Project: IEEE P802.15 Working Group for Wireless Personal Area Networks (WPANs)

Submission Title: [proposed resolutions about comments CID 664 and more]
Date Submitted: [July 08. 2009]
Source: [Taehan Bae, Jaeseung Son, Sridhar Rajagopal] Company [Samsung Electronics Co.,LTD]
Address [Dong Suwon P.O. Box 105, 416 Maetan-3dong, Yeongtong-gu, Suwon-si, Gyeonggi-do, 443-742
Korea]
Voice:[82-31-279-7293], FAX: [82-31-279-5130], E-Mail:[taehan.bae@samsung.com]

Proposed resolutions of CID 664 and more (664, 704, 711, 712, 483, 691, 700, 703, 449, 450 451, 453)

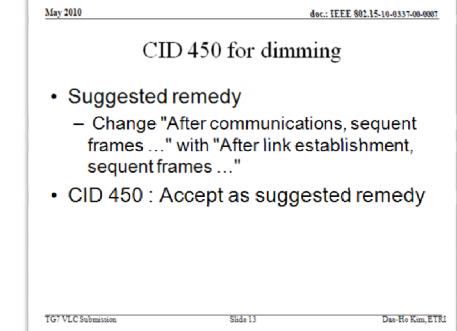
CID	Name	Clause	Subclau se	Pag e	Line	Comment	SuggestedRemedy			
450	R. Robe s	ert6.6.4 1		52		Make changes to the text below table 27	Change "After communications, sequent frames" with "After link establishment, sequent frames"	Kim	24 hr review a cuss in the ne re - reference 0/337r0	or futu

- We've discussed it in Beijing meeting like below 10/337r0.
- So, based on doc.10/337r0
- Accept
- refer the slide 13 in 10/337r0

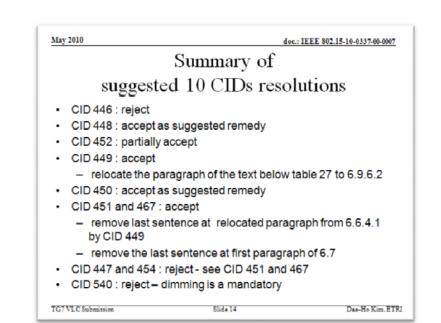
CID	Name	Clause	Subclau se	Pag e	Line	Comment	SuggestedRemedy			
451	R. Rob erts	6.6.4.1		52		Remove last sentence of the paragraph below table 27.	Remove the sentence "The transmitter should check the receiver's capability for dimming support before dimming using VPM". I don't understand why the transmitter should check if the receiver supports dimming. I would think dimming support is mandatory so this sentence should be removed.	Kim	24 hr review and ss in the near fut eference doc 10,	ure - r

- The theme been discussed before in Beijing meeting like 10/337r0.
- The author dose not agree with that Every each VLC device has dimming ability. The dimming support is optional.
- So, my suggested remedy is Reject.
- **TE:** do nothing.
